Doc or ECO #:	ECO-71152-004	Date:	06/14/2021	Author:	SL
	Rev. #:	A				
Engineering Change Order (ECO)	Engineering Approval:	aeg	Date:	6/14/2021	Quality Approval:	aeg

P/N #:	71152	Effective Date:	June 15, 2021
Title:	Pro 4 Ultra USB Hub Replacement

3.0 Detail

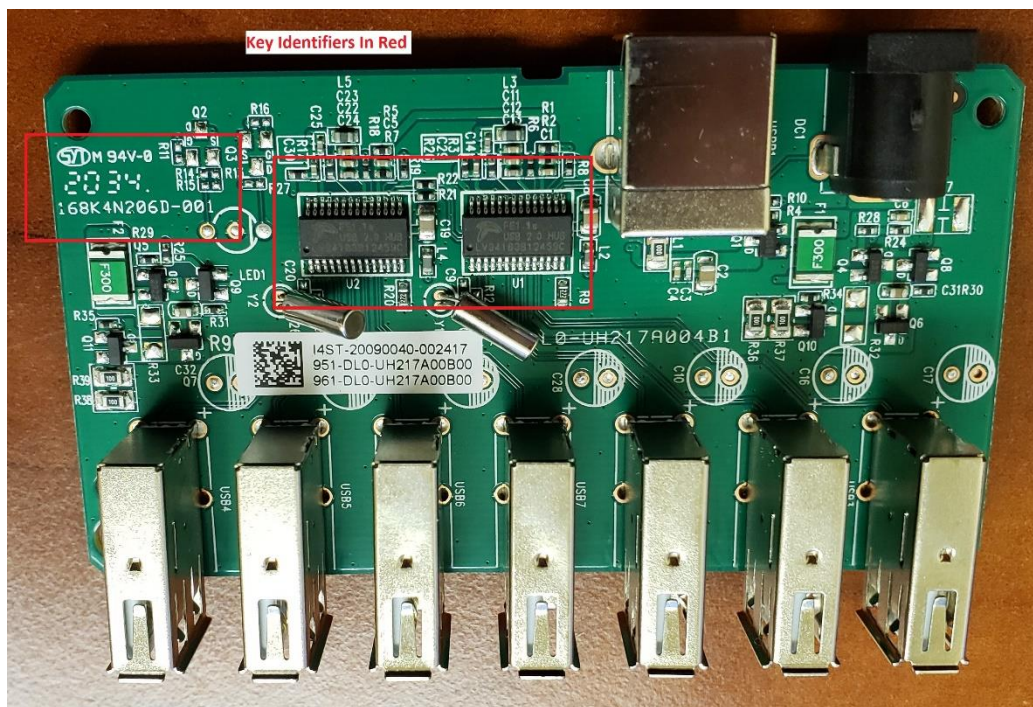
- Due to a PCB Revision update on the D-Link USB Hub **[PN4-014]**, the system was no longer stable and conflicting with Windows 10 Updates. The D-Link Hub was replaced with the Saberant USB Hub which comes standard on the base Pro 4 ICB.
- The Pro 4 Ultra Accessory Board **[71122]** has been updated to accommodate the Hub change.

- All current stock of the Pro 4 Ultra ICB [71152] including those in process in production should be updated to the standards of this ECO.
- Added Missing Shrink Tube Part Number to BOM
- Any Pro 4 Ultra system in the field exhibiting the following issues that a standard driver reinstallation does not fix should be inspected for the problematic USB Hub. If the problematic USB Hub is discovered in the system, the ICB should be sent to VideoRay for a warranty replacement. Due to the nature of the replacement, in field replacements are not advised. The photo below should be used to identify the problematic USB Hub.
